March 18, 2024

IDEA Public Schools Electrical Switchgear Upgrades at Multiple Campuses CSP#22-ESGU-0424

ADDENDUM NO. 1

1 LEVEL 1 FOUNDATION PLAN
 1/2" = 1'-0" +3'-0" ABOVE LEVEL 0

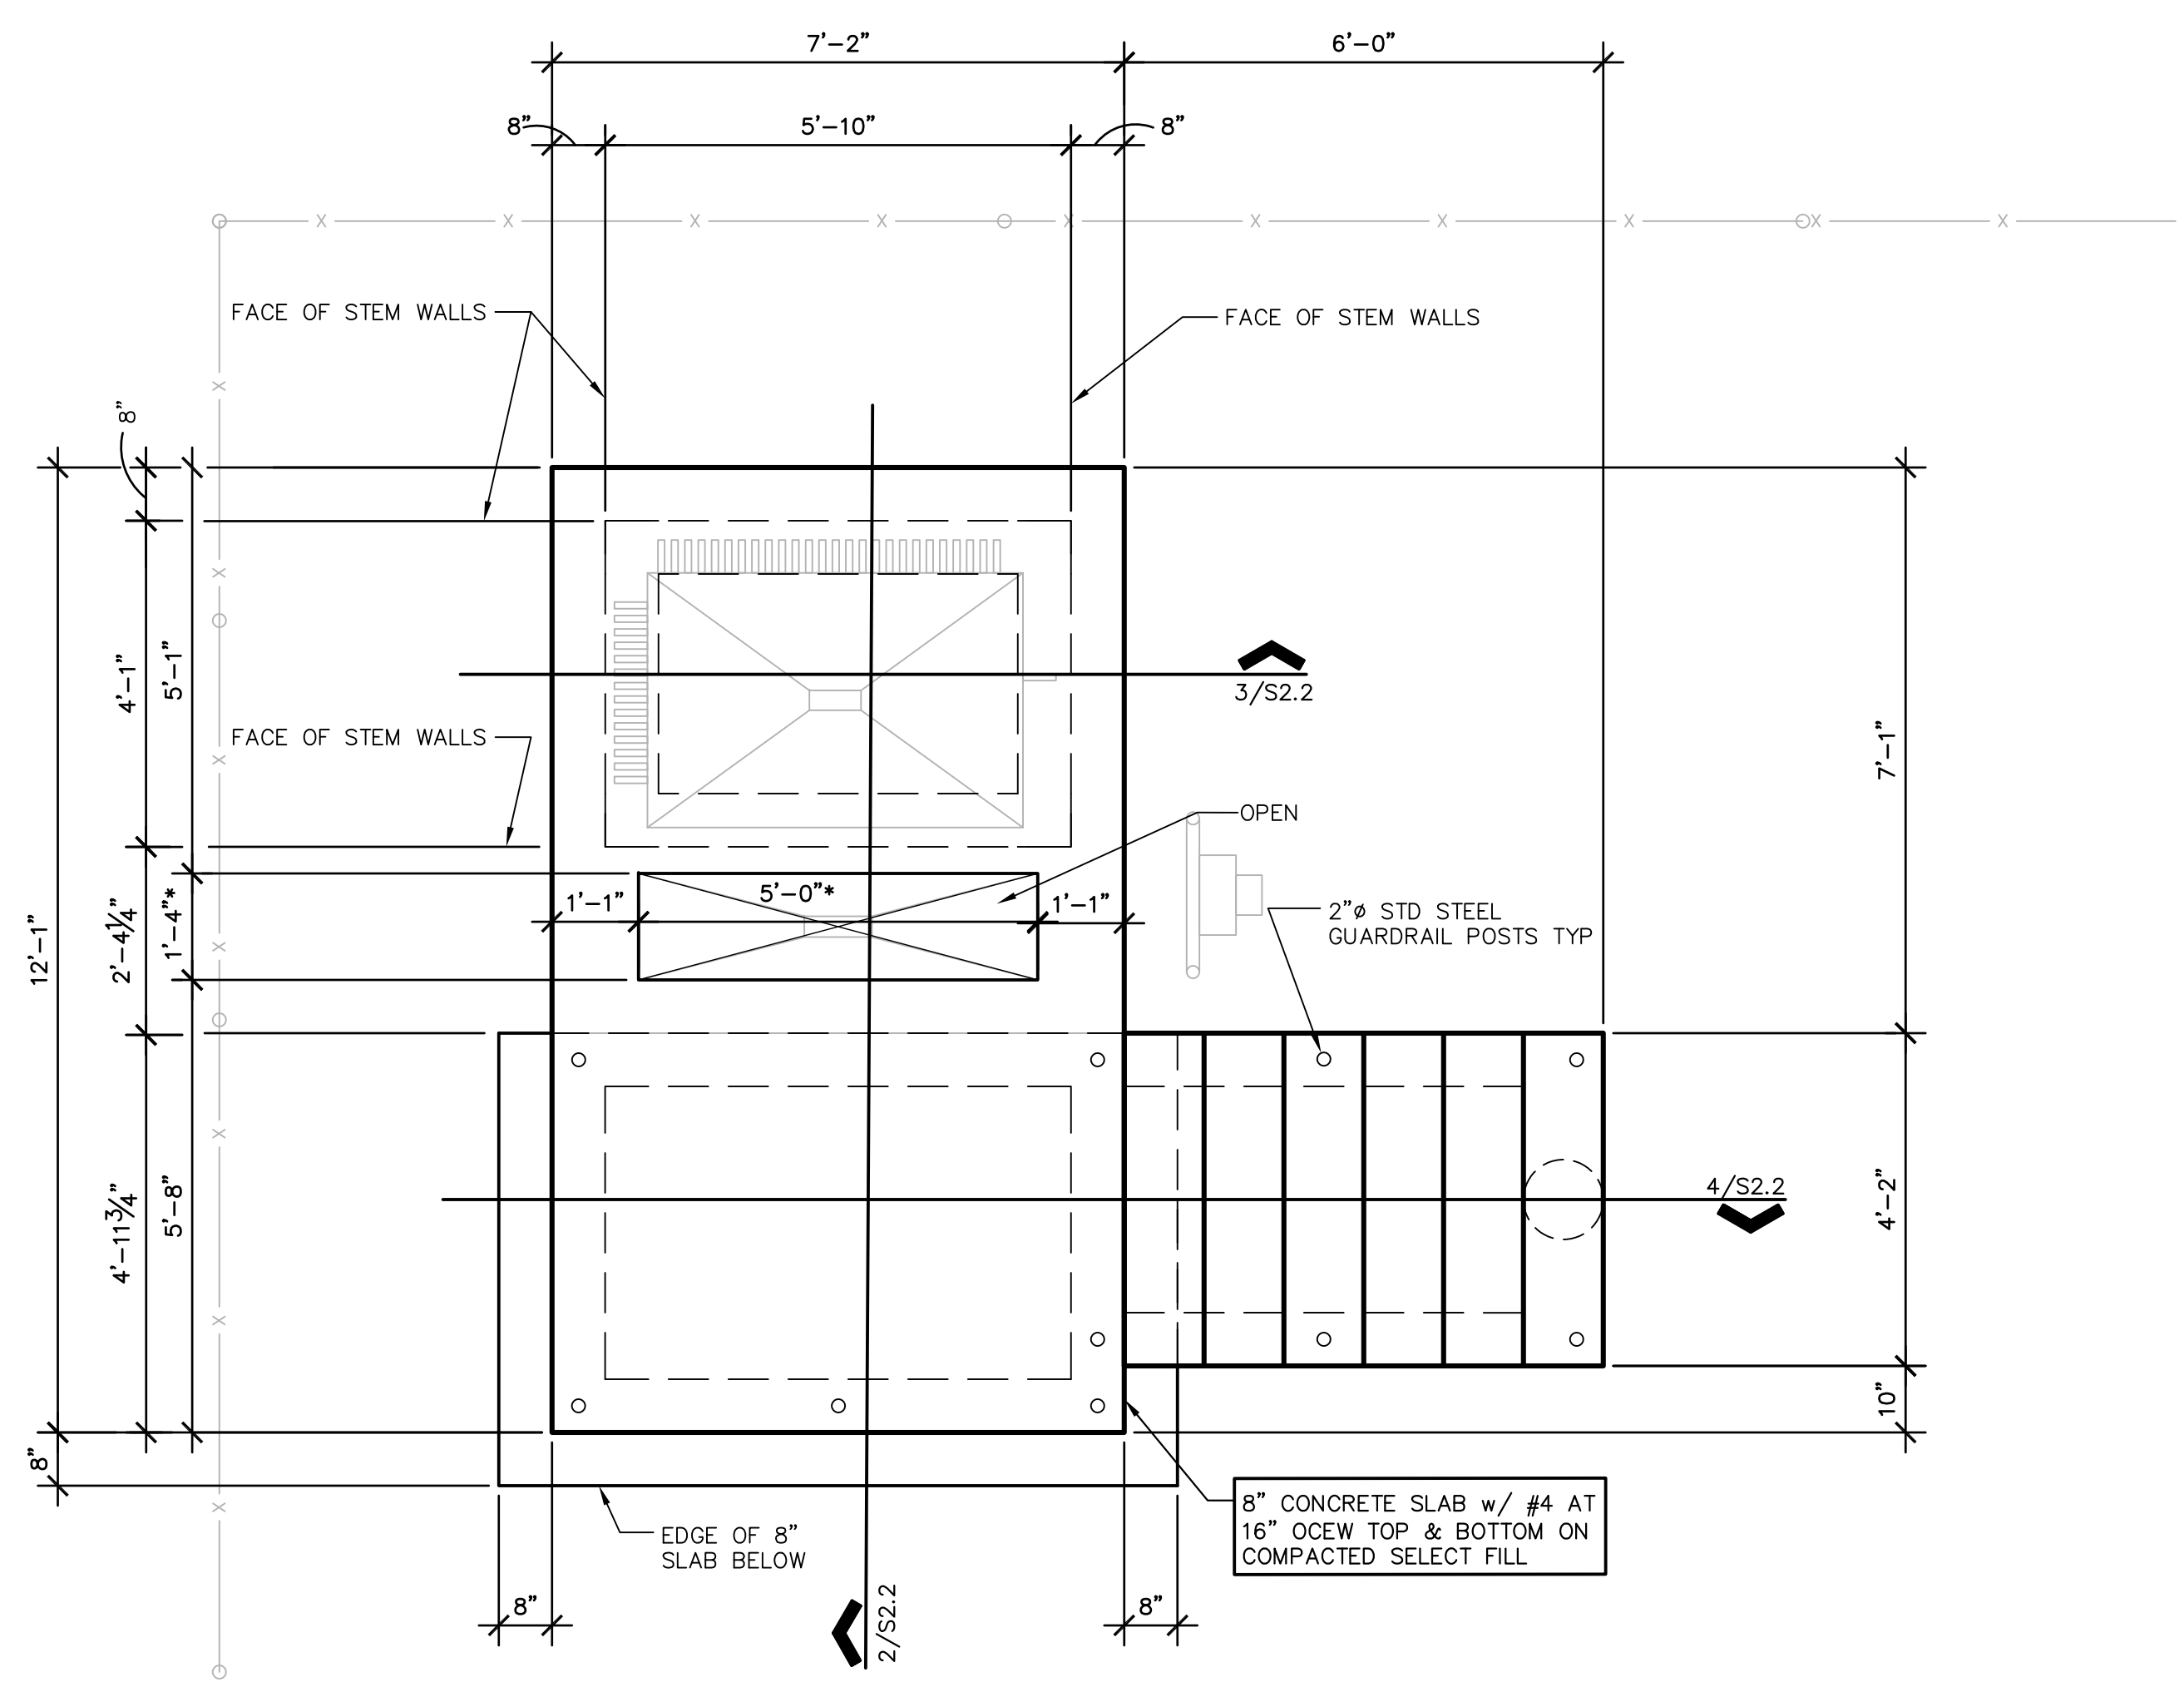
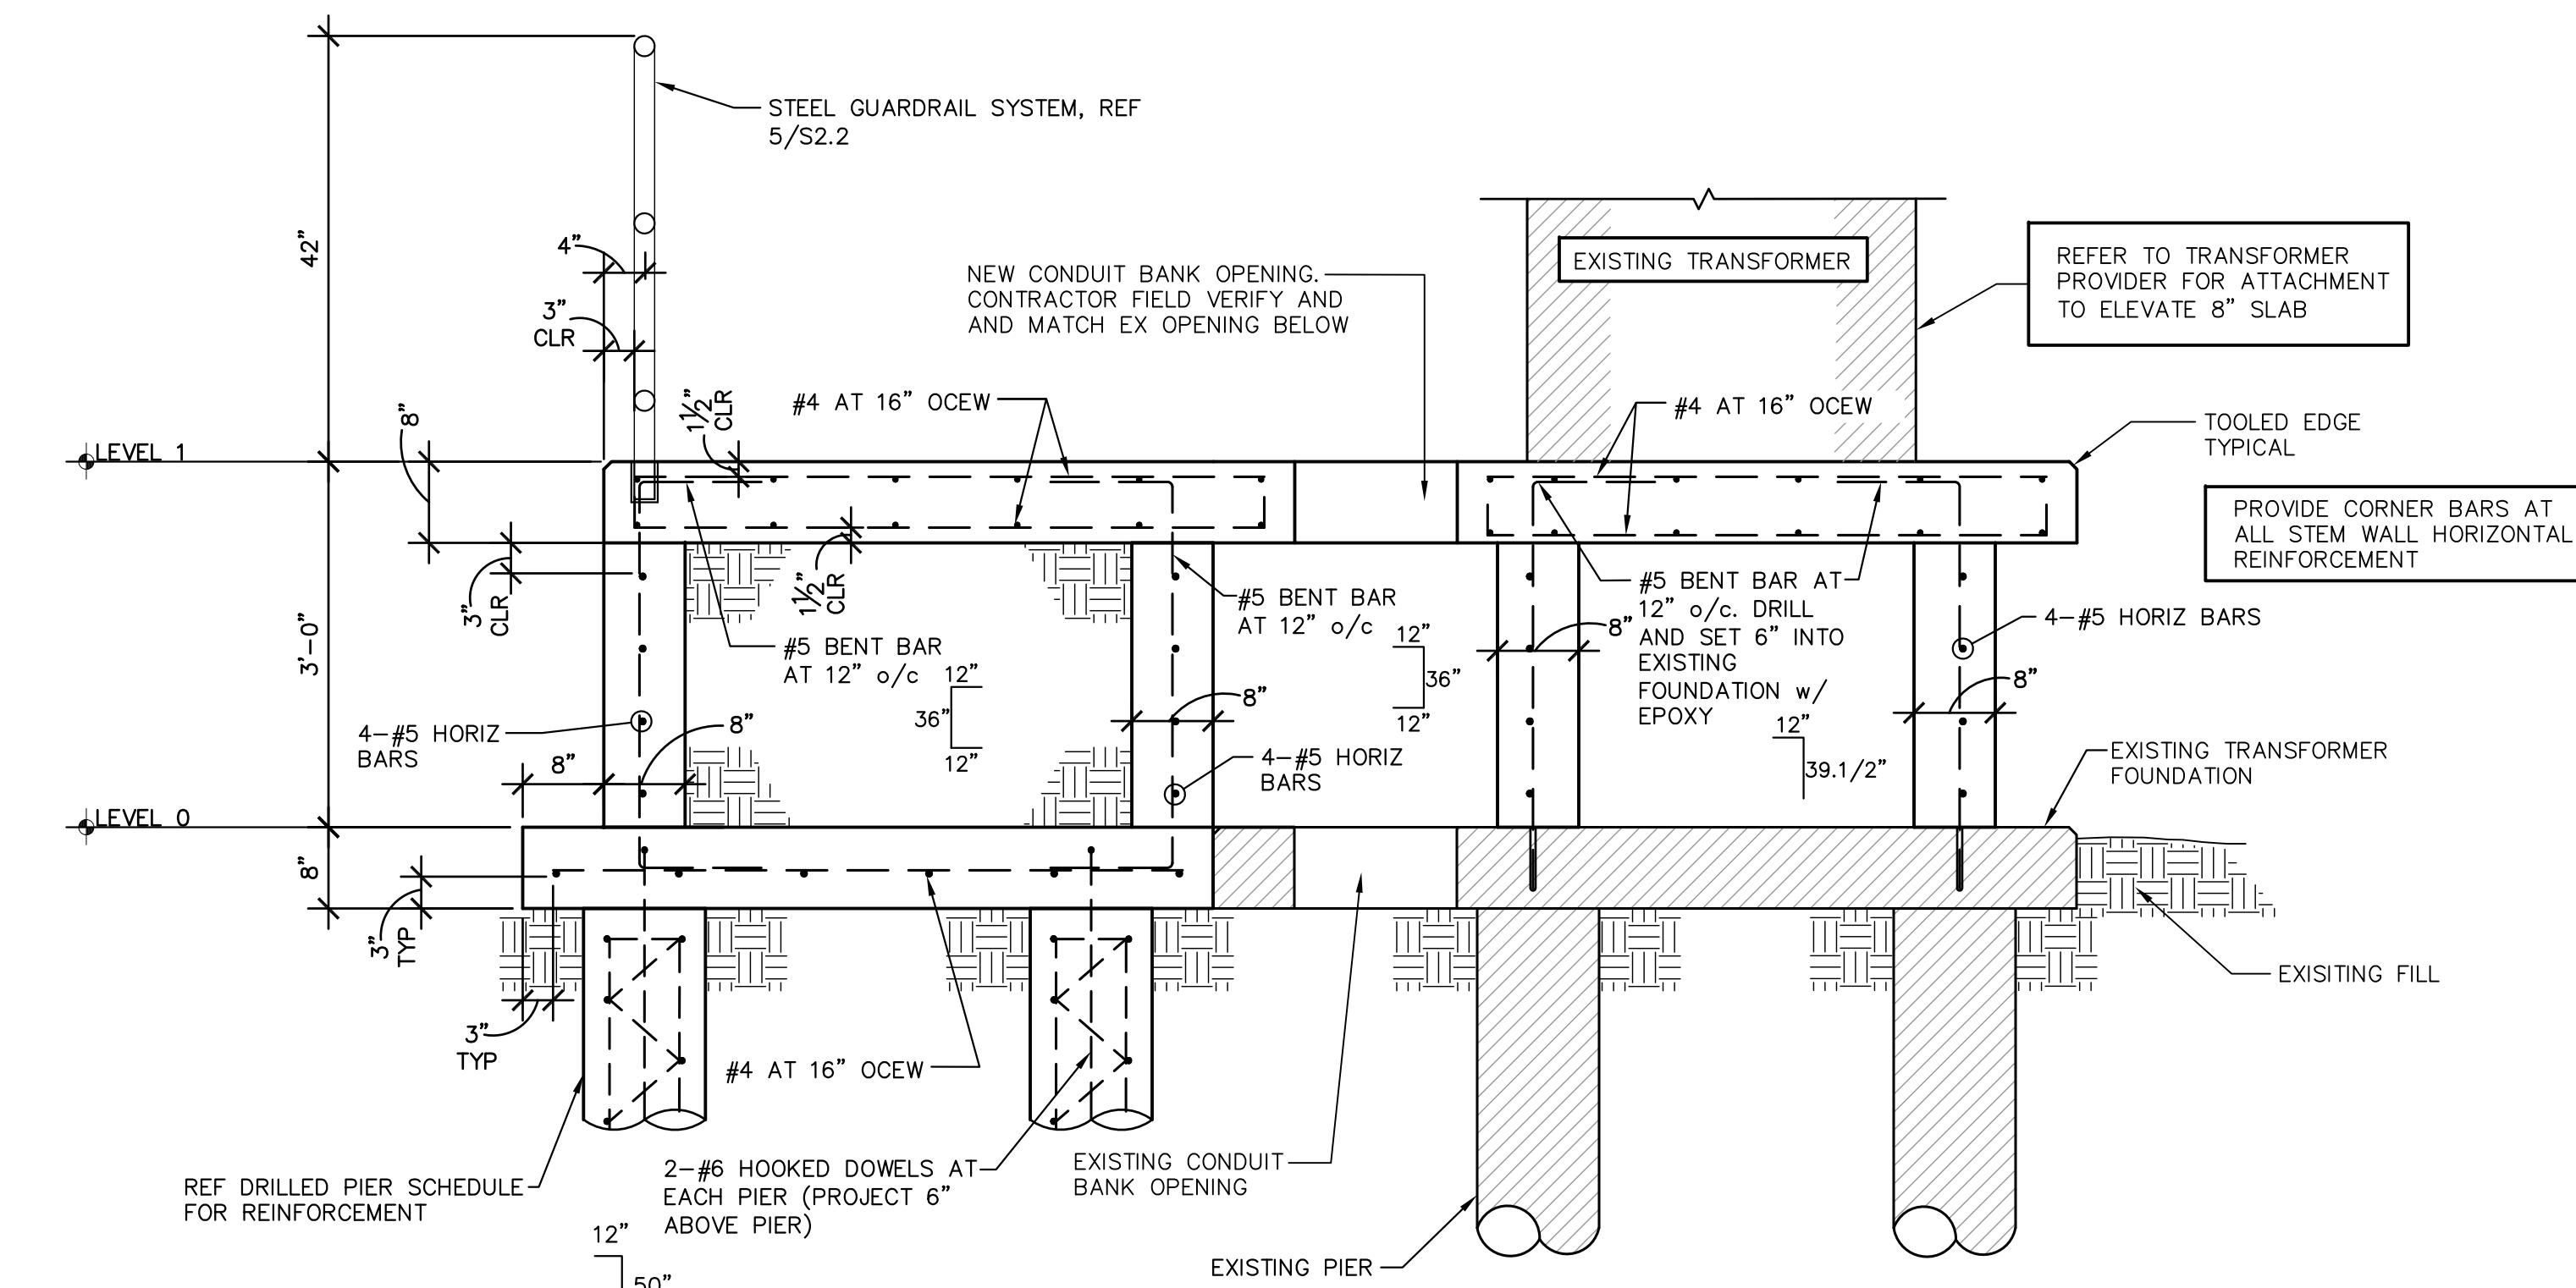
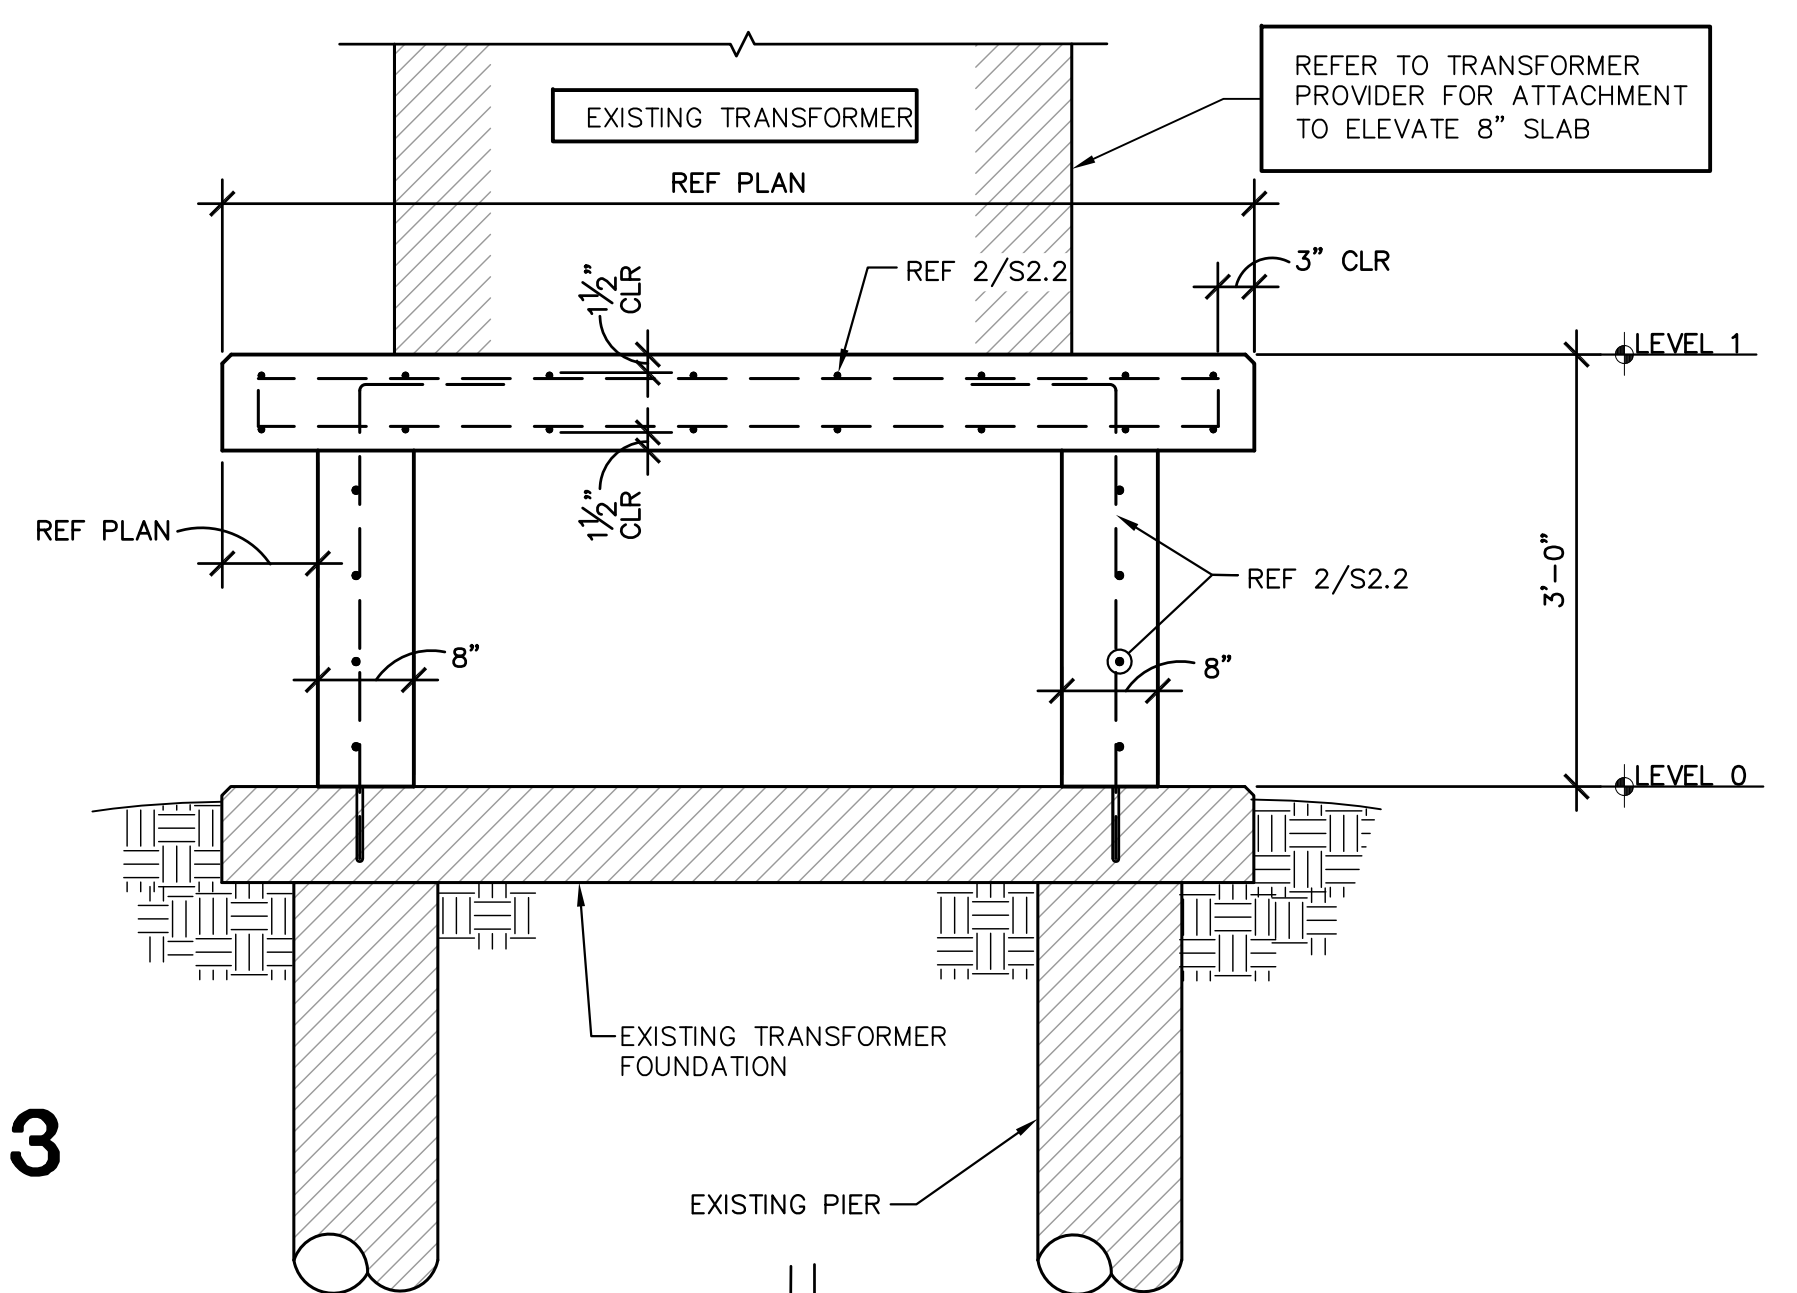
1. Cover:
 - a) Revised Executive Committee, Board of Directors, and Rio Grande Valley Regional Board. See attached sheet.
2. Sheet S1.1:
 - a) Added General Structural Notes. See attached sheet.
3. Sheet S2.1:
 - a) Added Structural Foundation Plan and Drilled Pier Profile. See attached sheet.
4. Sheet S2.2:
 - a) Added Structural Foundation Plan and Elevations. See attached Sheet.

- NOTES:
- COORDINATE FOUNDATION, STAIRS AND ORIENTATION WITH M.E.P SITE PLAN
 - * INDICATED DIMENSIONS THE CONTRACTOR WILL NEED TO FIELD VERIFY AND MATCH EXISTING TRANSFORMER CONDUIT BANK OPENING SIZE.
